Agenda
Village of Glen Ellyn
Architectural Appearance Commission Special Meeting
Wednesday, August 16, 2023
7:00 PM
Glen Ellyn Civic Center, Galligan Board Room

REQUEST: The petitioner is requesting an Exterior Appearance Review for construction of a Popeyes Louisiana Kitchen restaurant. The proposed restaurant is 2,515 square feet. The restaurant will contain a drive-through, as well as interior order counter and seating for 24. To proceed with the project, the petitioner will need to receive approval of the Exterior Appearance of the proposed improvements. A Zoning Map Amendment, Special Use Permit and Zoning Variations are also being sought. These additional issues will be reviewed by the Plan Commission. Recommendations from both citizen review bodies will be forwarded to the President and Village Board of Trustees.

1 STANDARD DUMPSTER ENCLOSURE
SCALE: 3/8" = 1'-0"

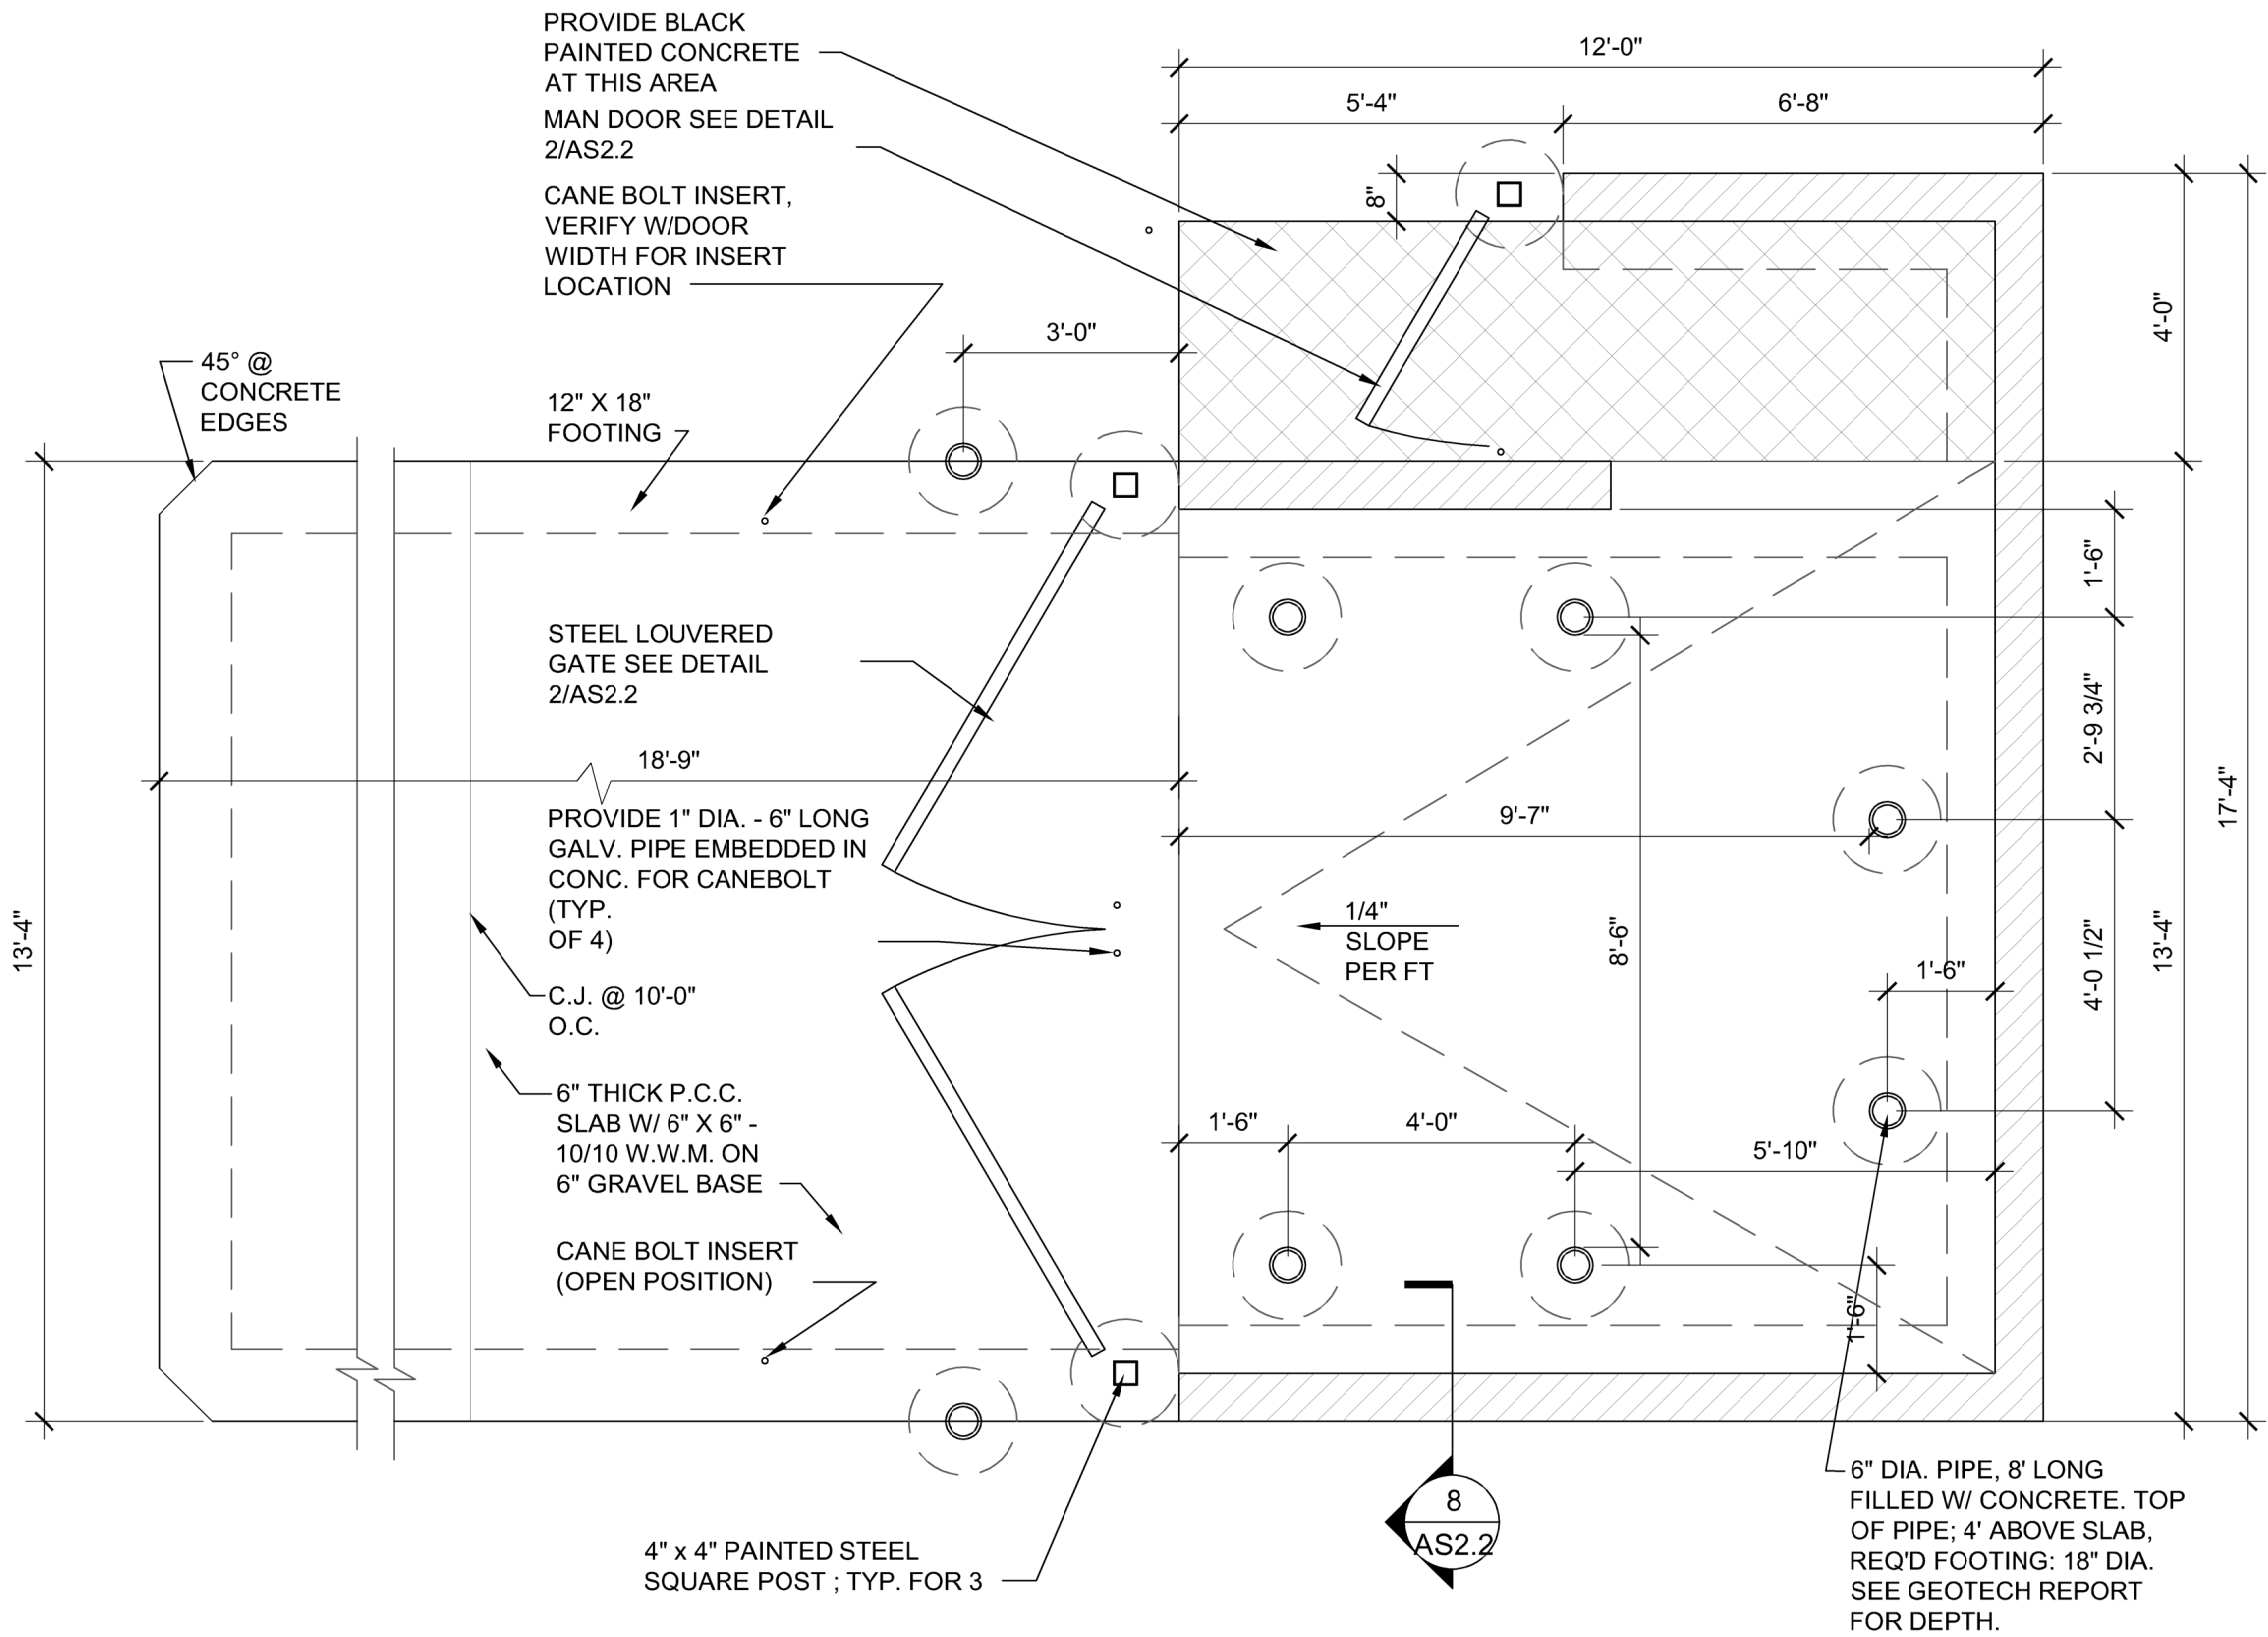
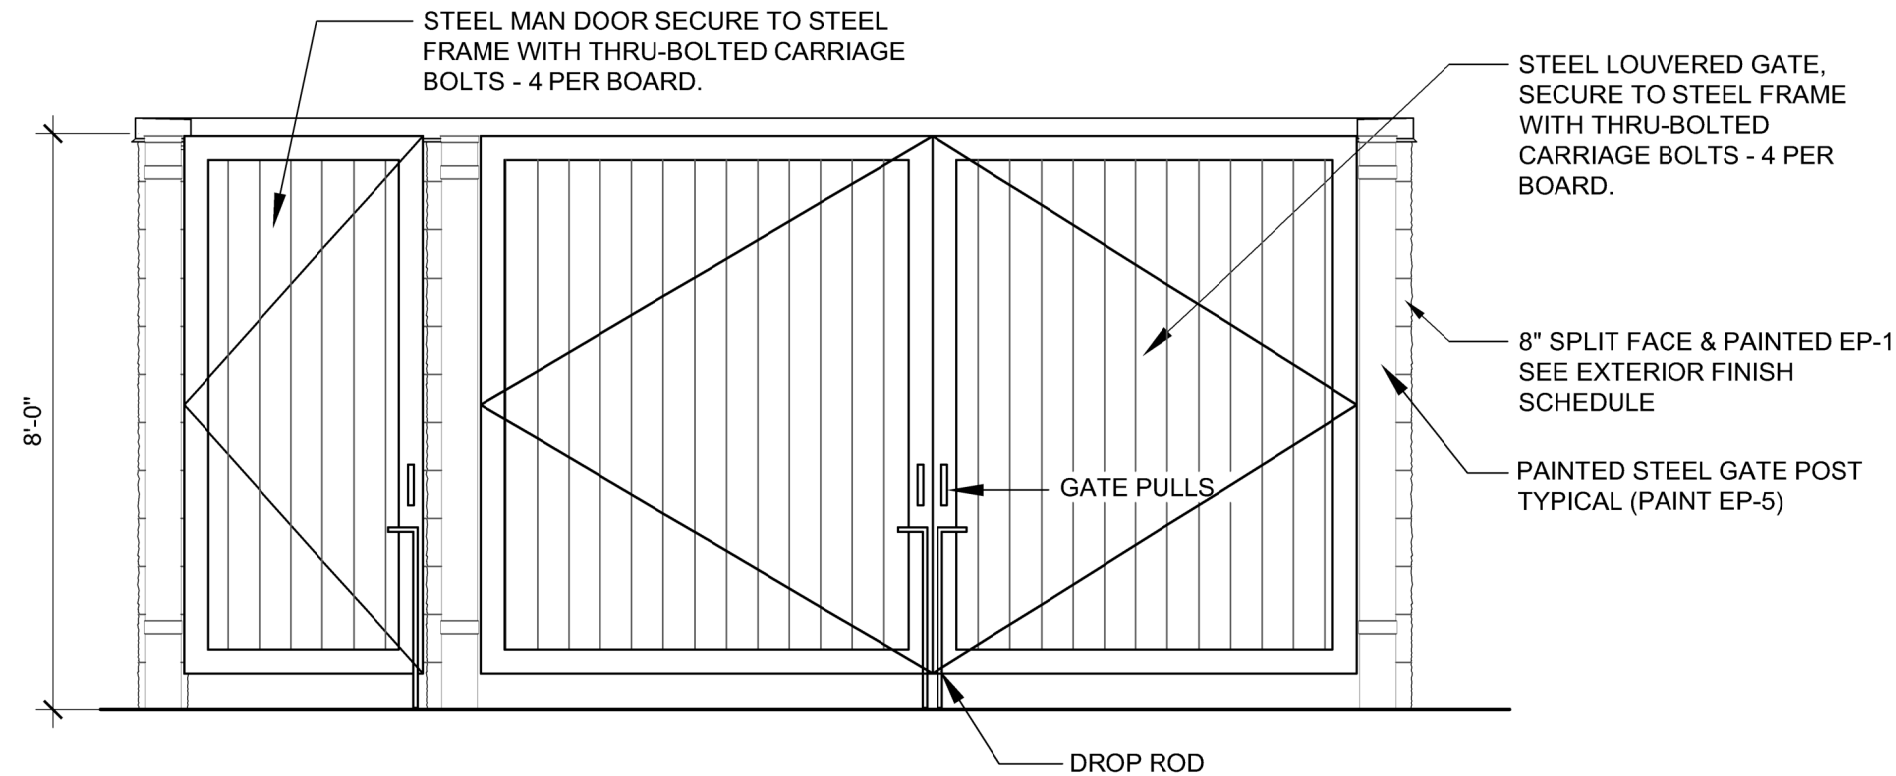
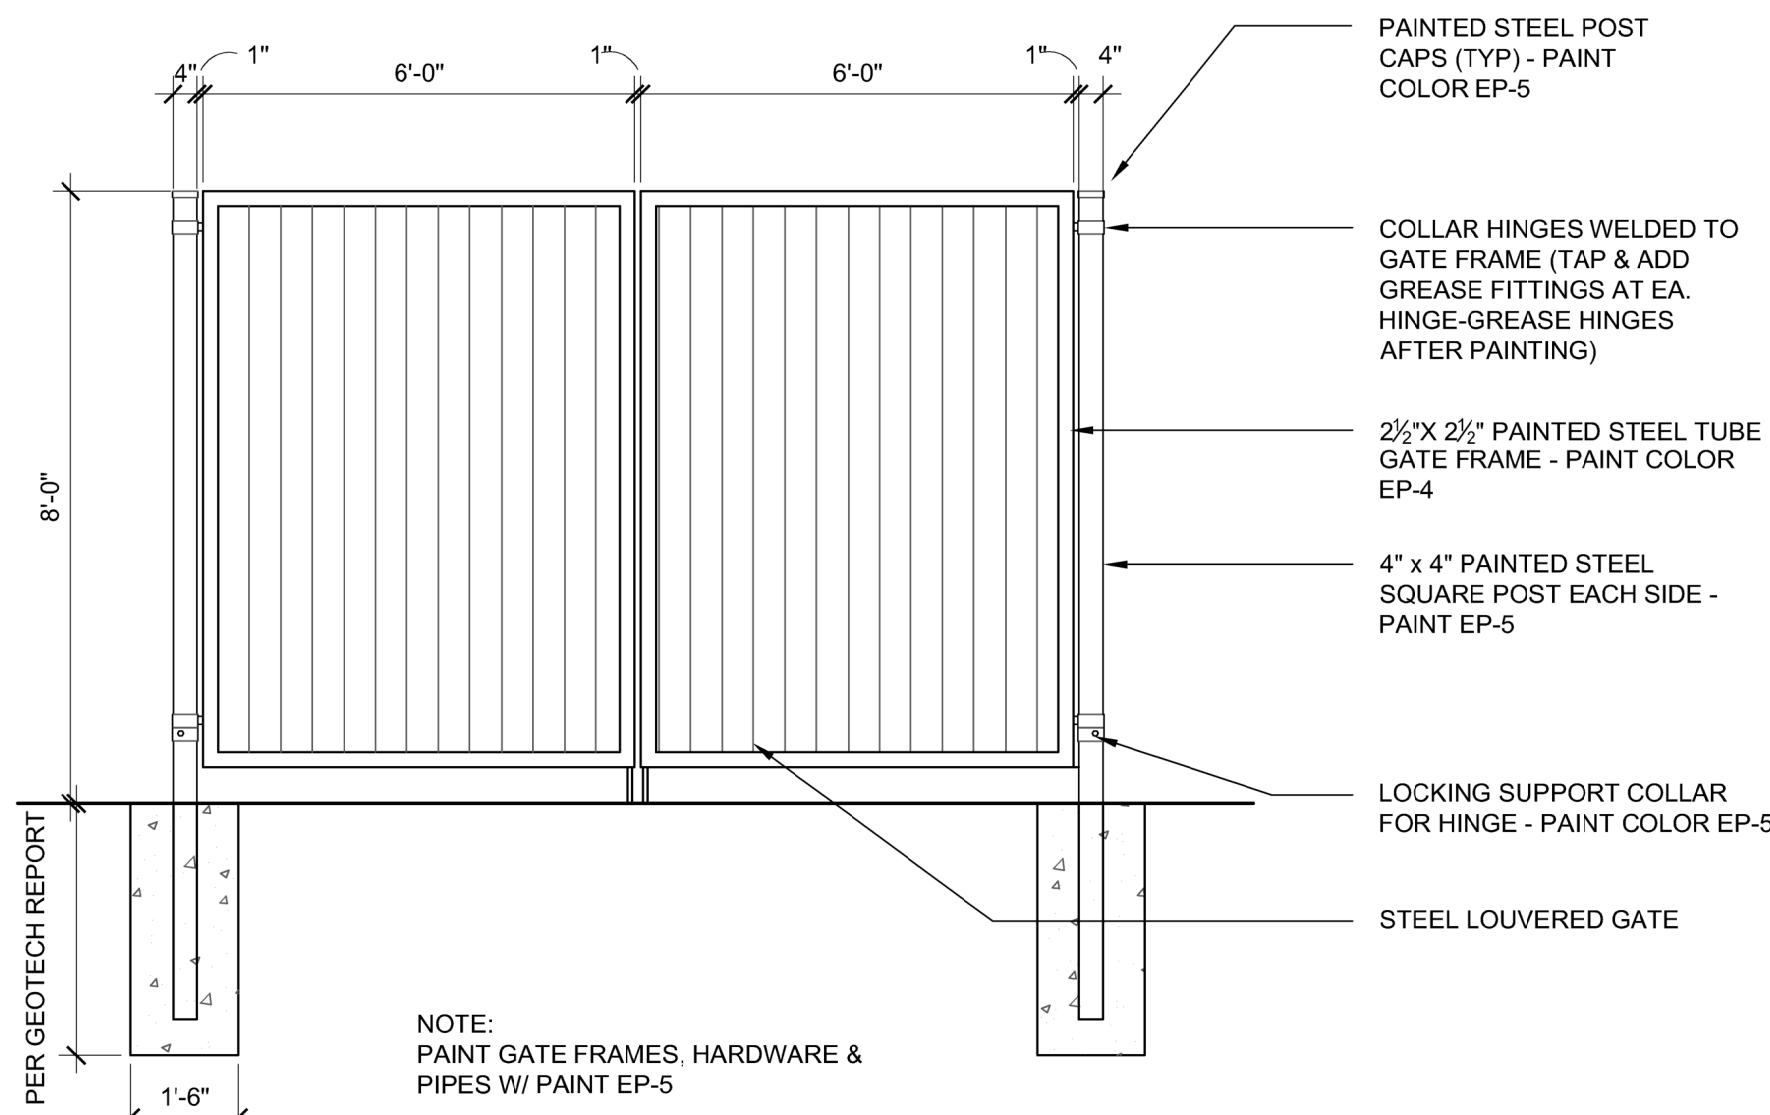
The masonry trash enclosure is sited at the northern end of the entry drive. Virtually every customer that enters the site will have a full view of the trash enclosure. While they have added plant material around the enclosure walls, the view of the enclosure remains prominent.

Staff believes the plan as presented with the siting / location of the trash enclosure requires a deviation from this guideline.

PLANT MATERIAL SCHEDULE

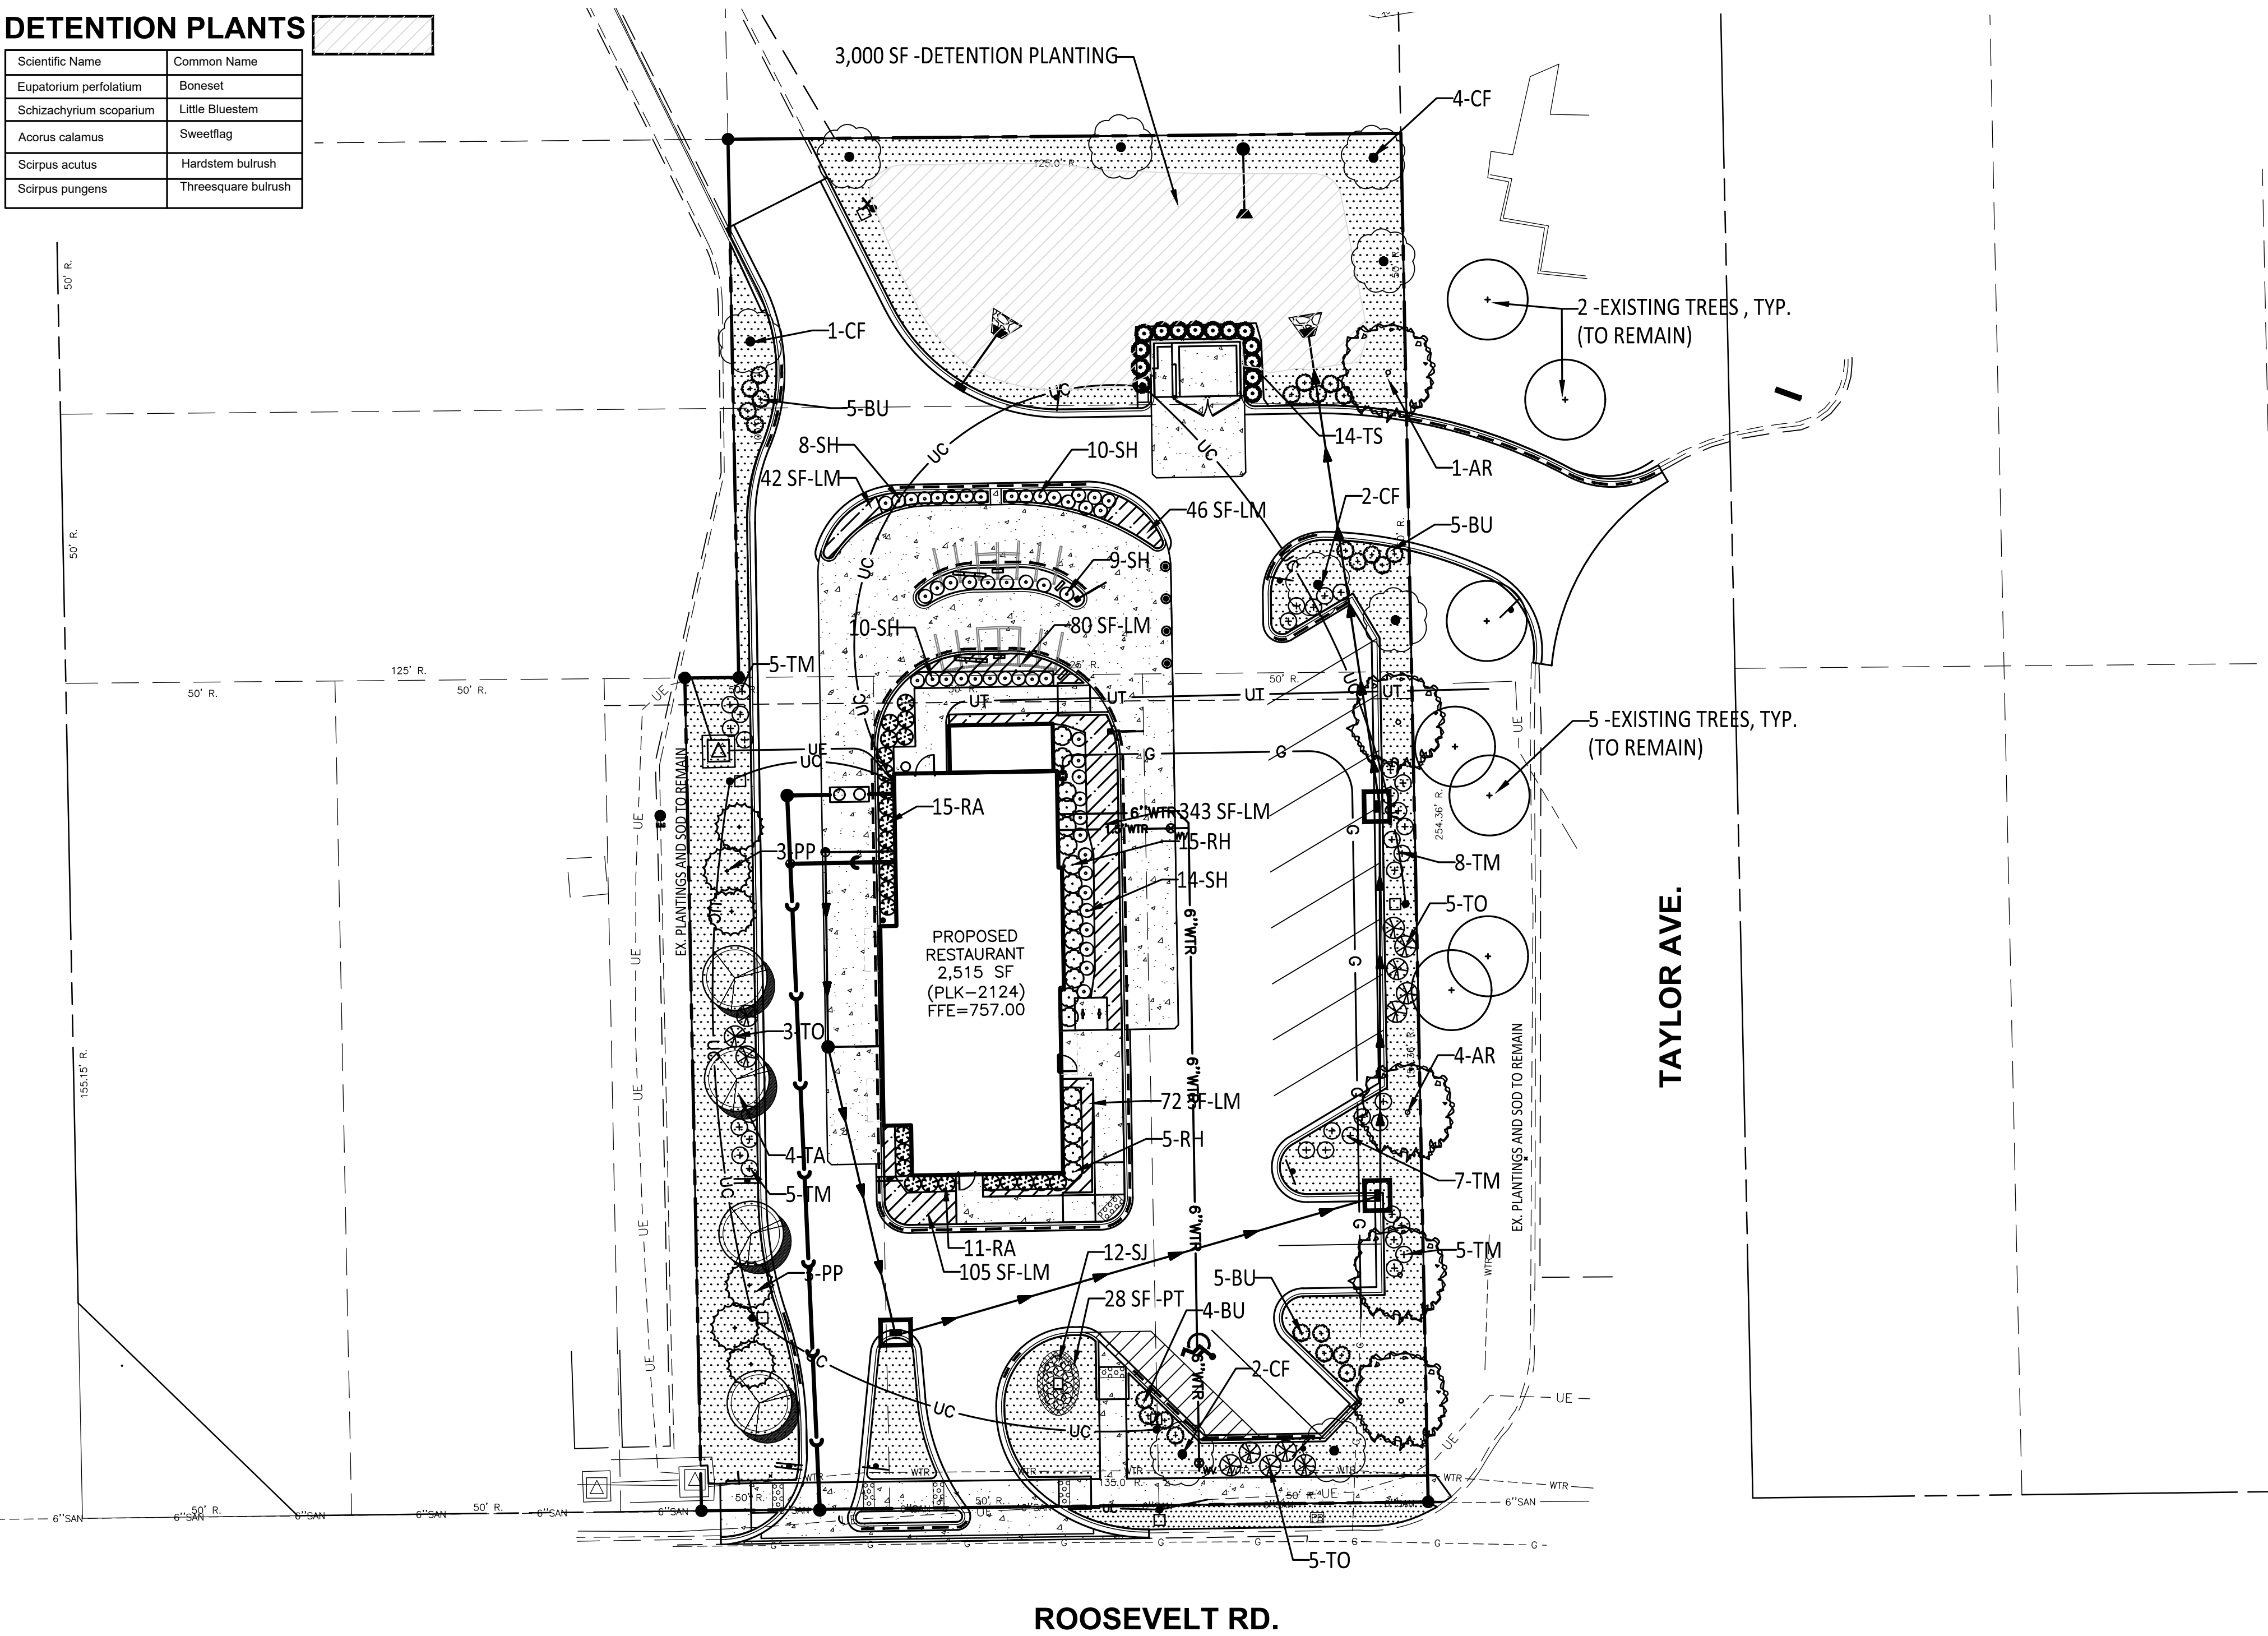
Landscaping. The petitioner has submitted a landscape plan which is included in your review materials (Sheet C500 Landscape Plan). Common sod is to be placed along the South, east and west property lines with trees and shrubs added on the east and west. Along the south Roosevelt Road frontage additional plantings surround the monument sign. Foundation planting for the building include shrubs and grasses.

Petitioner has revised their Landscape Plan in accordance with previous staff comments. The Plan is acceptable to the municipal staff.

Petitioner has revised their plan to include the provision of evergreen plants (Chicagoland Boxwood, Hicks Yew, and Hetz Midget Arborvitae) in and around the parking area. The plan now meets this guideline.

The revised plan now has appropriate landscaped islands to meet this guideline.

The mix of evergreens and deciduous shrubs, along with perennials and ornamental grasses, it should provide color throughout the growing season.
